METROPOLITAN GOVERNMENT OF NASHVILLE AND DAVIDSON COUNTY

Metropolitan Historic Zoning Commission
Sunnyside in Sevier Park
3000 Granny White Pike
Nashville, Tennessee 37204
Telephone: (615) 862-7970
Fax: (615) 862-7974

STAFF RECOMMENDATION 1514 Woodland Street December 19, 2018

Application: New Construction—Addition and Outbuilding; Demolition—Outbuilding
District: Lockeland Springs-East End Neighborhood Conservation Zoning Overlay
Council District: 06
Map and Parcel Number: 08309046800
Applicant: Cheyenne Smith
Project Lead: Melissa Baldock, melissa.baldock@nashville.gov

FLOOR PLANS

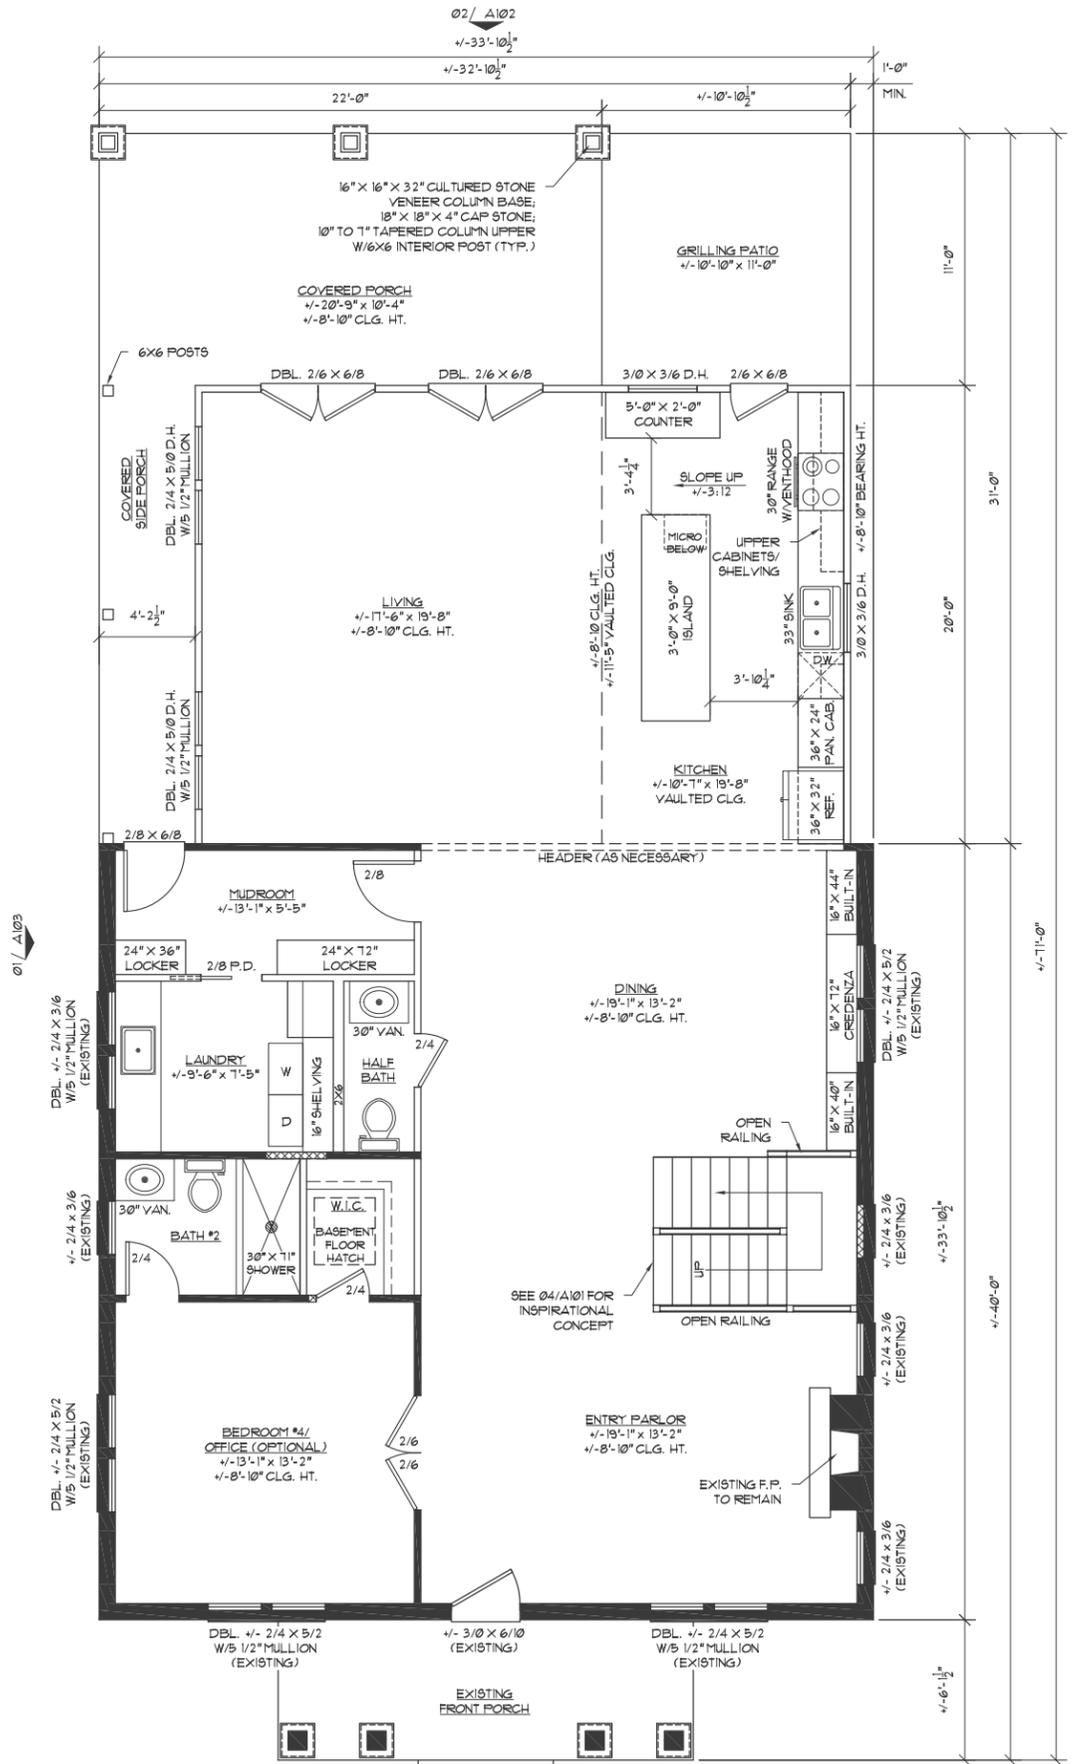
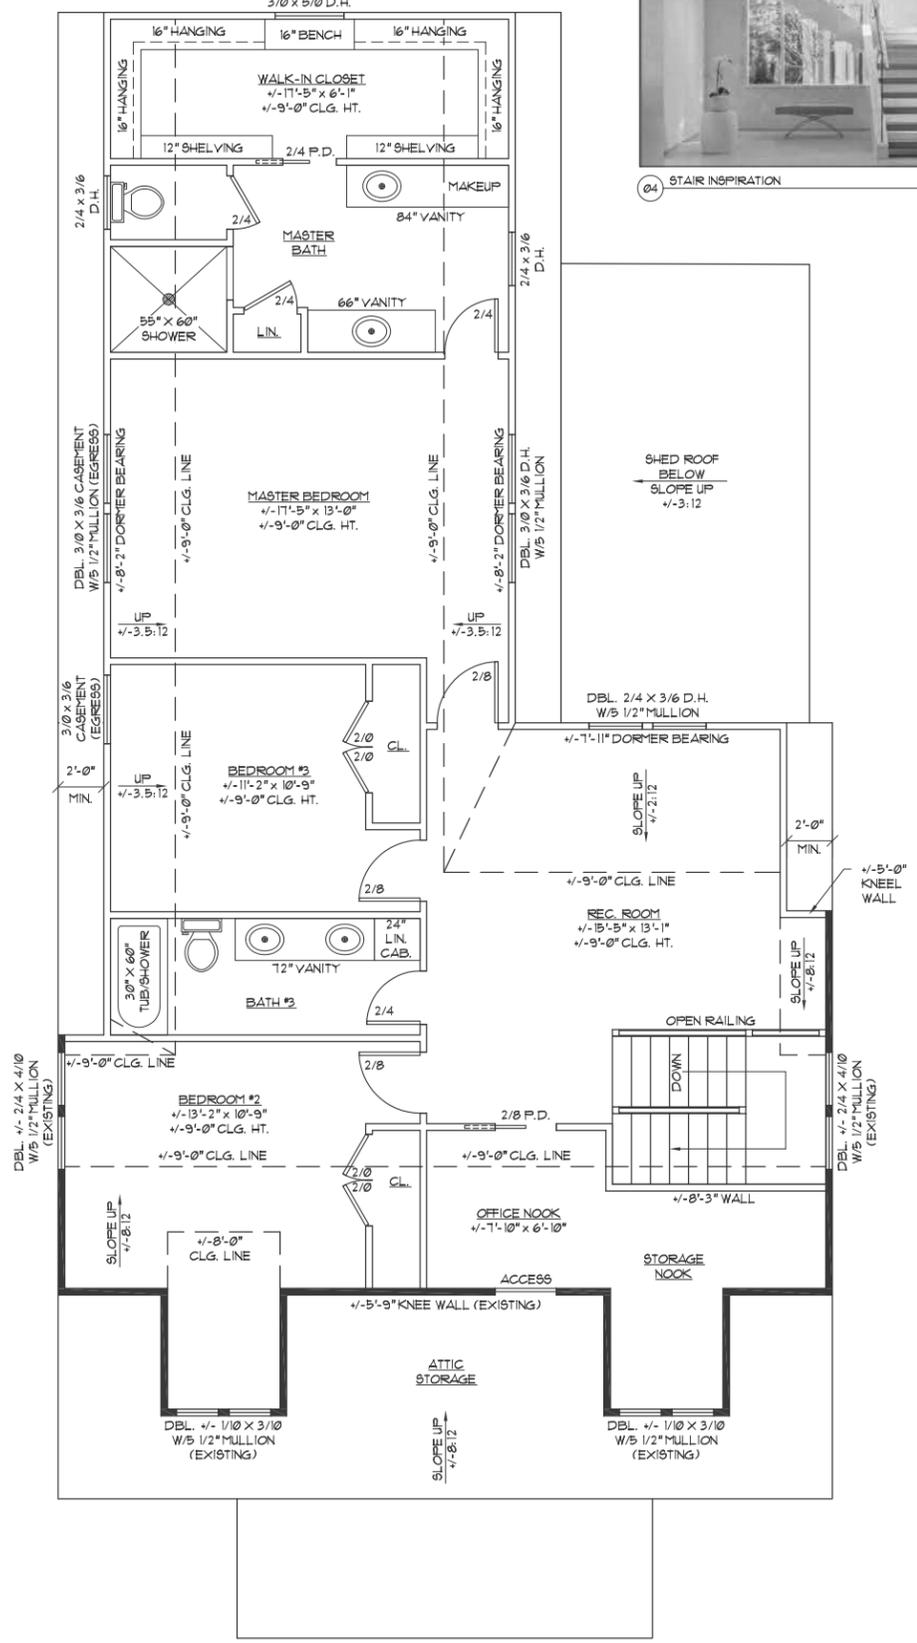
The addition will have a depth of thirty-one feet (31'). It will add approximately one thousand and eighteen square feet (1,018 sq. ft.) of space to the historic house, which was a footprint of one thousand, two hundred, and twenty-eight square feet (1,228 sq. ft.).

01 RIGHT ELEVATION (WEST)
MAIN RESIDENCE

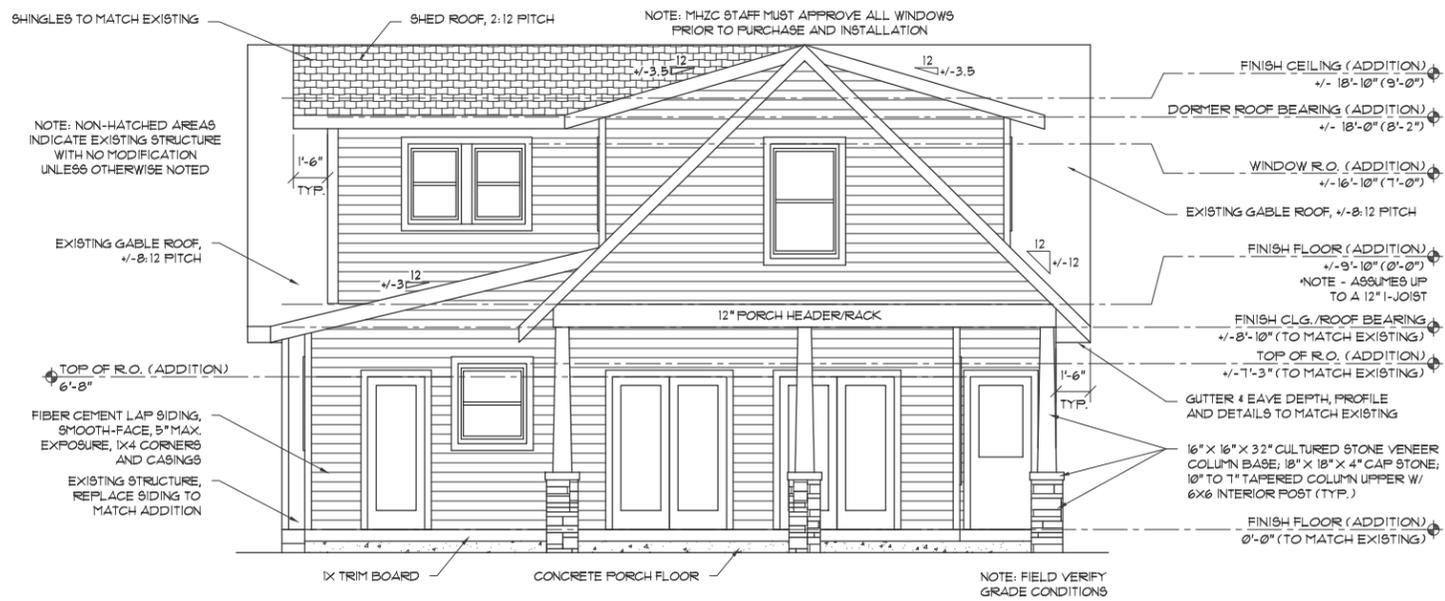
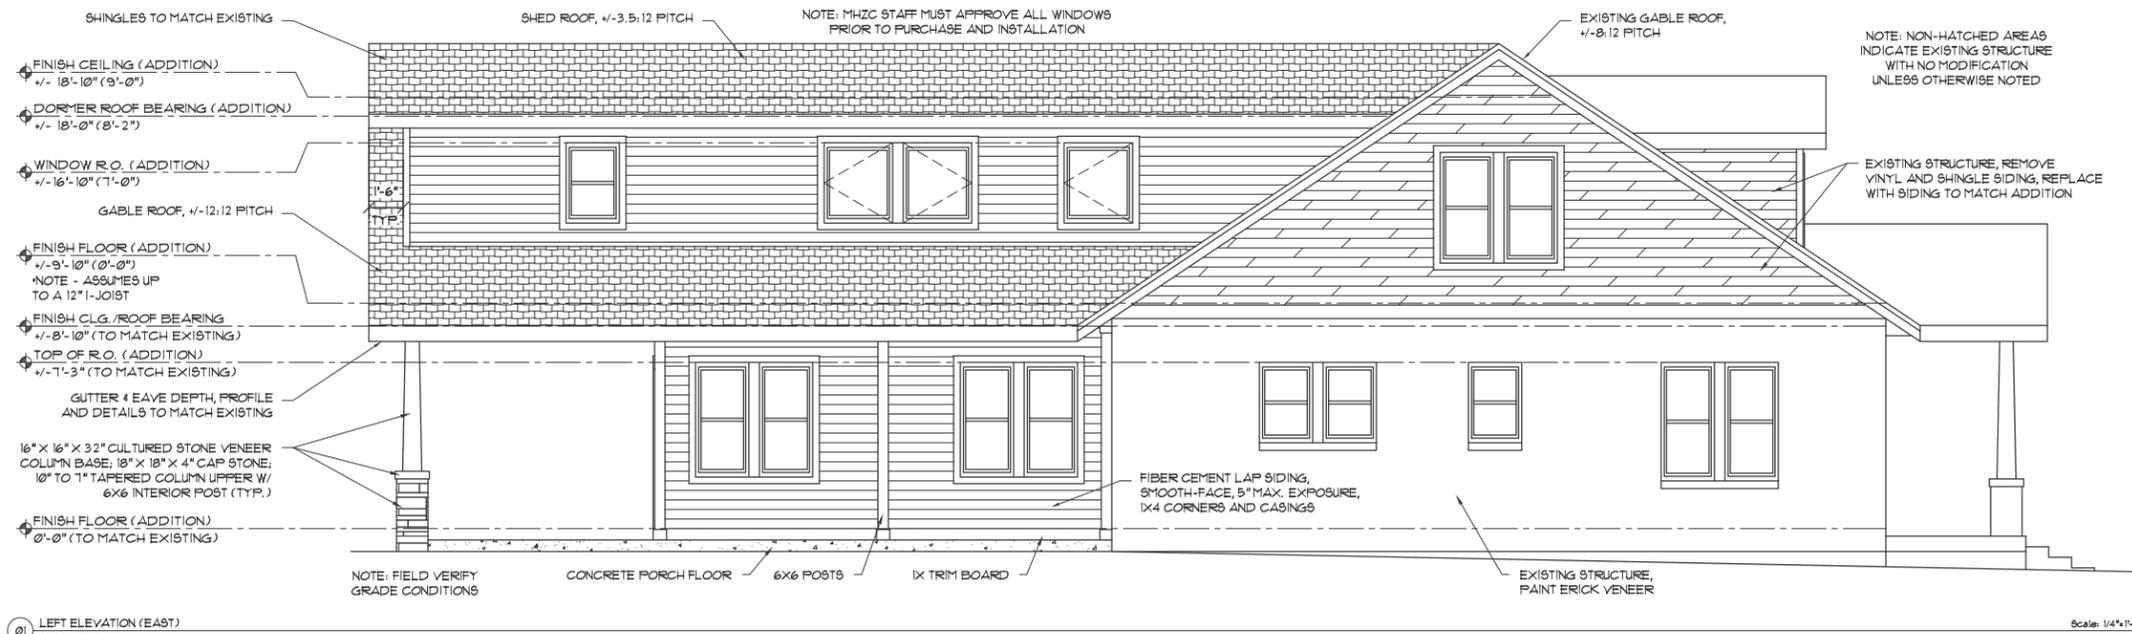
The applicant also intends to remove a window opening on the right side façade (Figure 3). Staff finds the removal of the window opening to be appropriate, in this instance, because the window is at the midpoint of the house and is not highly visible from the street. In addition, no other window openings will be altered, so this change is relatively minimal. The opening's removal will not detrimentally impact this historic character of the house.

On the right side, the first floor is inset one foot (1'), which is appropriate. The bulk of the second story is inset thirteen feet (13') on the right side. The rear dormer is inset two feet (2') on both sides, as is typically required. On the left side, the wall of the addition is inset approximately four feet, three inches (4'3"). However, there is an open porch element that is flush with the wall of the house. Staff finds the lack of inset of the open porch to be acceptable for several reasons. One, the porch is entirely open. Second, because the house is brick and the porch is open, the addition is distinguished as a newer portion by the change in materials. Lastly, the back corner of the house will remain intact. The second level is inset two feet (2') from the back wall, as is typically required.

Roof form: The historic house has a side gable roof form with a slope of about 7/12. The addition includes a rear shed dormer with a slope of 2/12; the rear dormer is inset two feet (2') from the side wall of the house. The addition also includes a rear-facing gable form with a slope of 12/12. This gable has shed roof dormers with slopes of 3.5/12. The rear porch has a shed roof form with a slope of 3/12. Staff finds that the proposed roof forms are compatible with the historic house and meet Sections II.B.5. and II.B.10. of the design guidelines.

Proportion and Rhythm of Openings: The removal of the window opening on the right façade is discussed under "Partial Demolition." The windows on the proposed addition are largely vertically oriented, meeting the historic proportion of window openings. There are no large expanses of wall space without a window or door opening. Staff finds the project's proportion and rhythm of openings to meet Sections II.B.7. and II.B.10.

02 FRONT/REAR ELEVATIONS (NORTH/SOUTH)
CARPORT

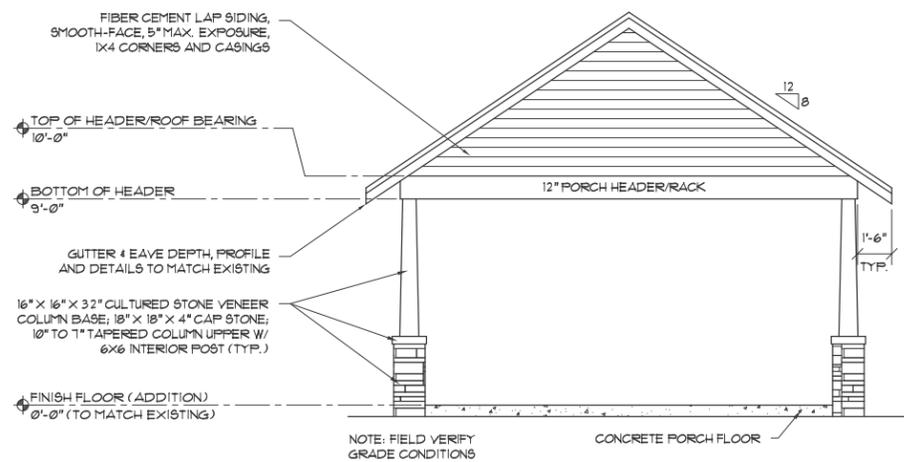
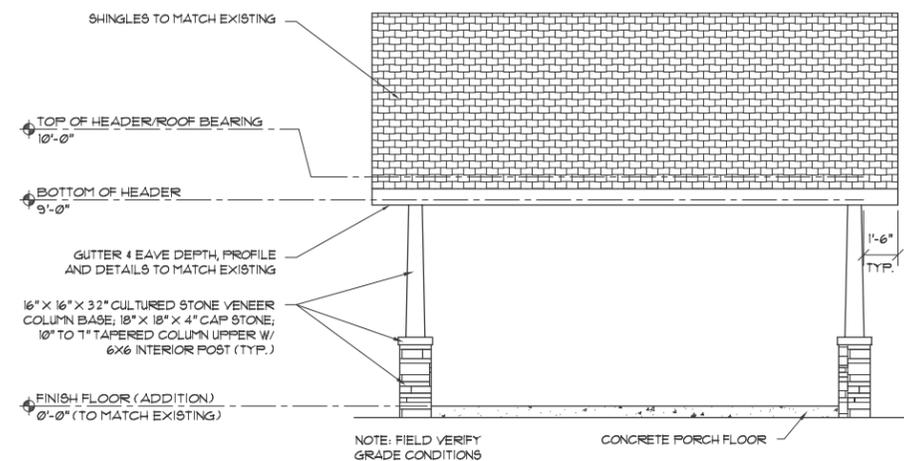
Design Standards: The carport structure has a simple, utilitarian design that is appropriate for outbuildings. Its roof form, detailing, and form do not contrast greatly with the primary structure. The outbuilding will be located at the rear of the house in a minimally-

04 SITE PLAN

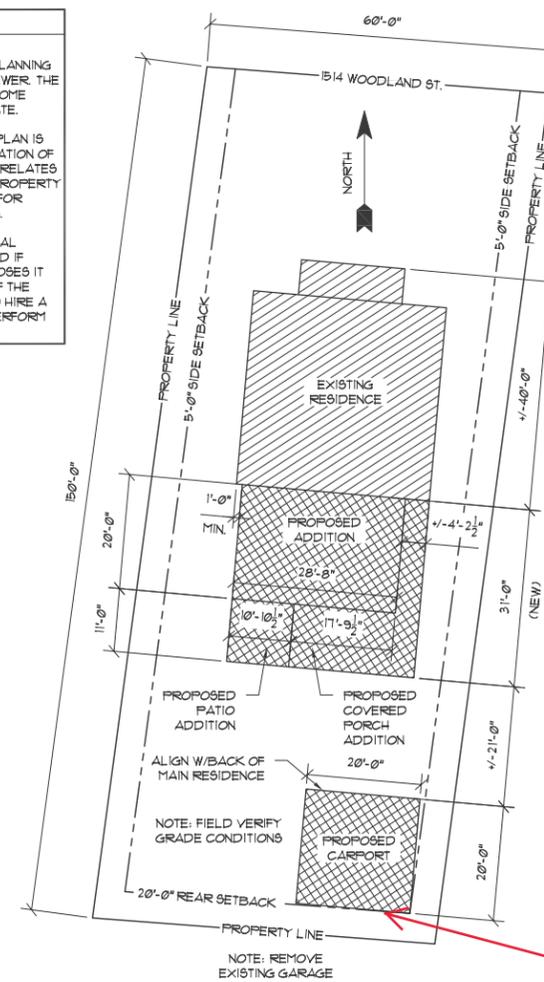
Setback & Rhythm of Spacing: The proposed addition meets all base zoning setbacks. It will be approximately ten feet (10') from the left side property line and sixteen feet (16') from the right side property line. It will be over forty-five feet (45') from the rear property line. Since the addition will be located entirely behind the historic house, it will not affect the rhythm of spacing of historic houses along Woodland Street. Staff therefore finds that the proposed addition meets Sections II.B.3. and II.B.10. of the design guidelines.

MINIMUM	PROPOSED
Space between principal building and DADU/Garage	20'	21'
Rear setback	3'	5'
L side setback**	3'	5'
R side setback**	3'	35'
How is the building accessed?	From the alley or existing curb cut	Alley
